Amendments to the Drawings:

REMARKS

The Office Action mailed June 29, 2004, has been received and reviewed. Claims 1 through 51 are currently pending in the application. Claims 1, 2, 4, 6, 21, 22, 24, 25, 29, 31 and 47 stand rejected. Claims 3, 5, 7 through 20 and 23 have been objected to as being dependent upon rejected base claims, but the indication of allowable subject matter in such claims is noted with appreciation. Claims 26 through 28, 30, 32 through 46 and 48 through 51 are allowed. Applicants have amended claims 4, 21, 29 and 47. Reconsideration is respectfully submitted.

Fig. 11

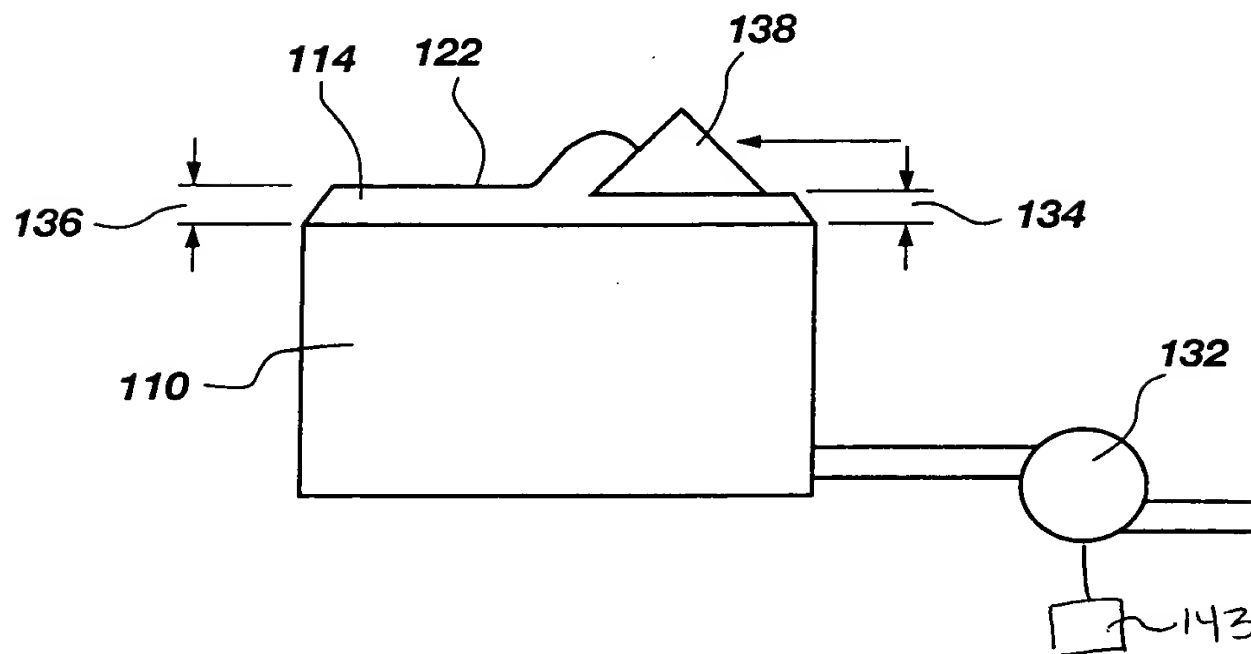
The drawings were objected to for failing to illustrate a vacuum. Applicants have amended Figs. 11 and 12 to illustrate a vacuum as described in the as-filed specification in paragraphs [0045] and [0053] and the description of Fig. 18. The specification has been amended at paragraph [0045] to include a reference numeral for the vacuum. No new matter has been added. Reconsideration and withdrawal of the objection is requested.

The attached sheet of drawings includes changes to FIGS. 11 and 12. This sheet, which includes FIGS. 11 and 12, replaces the original sheet including FIGS. 11 and 12.
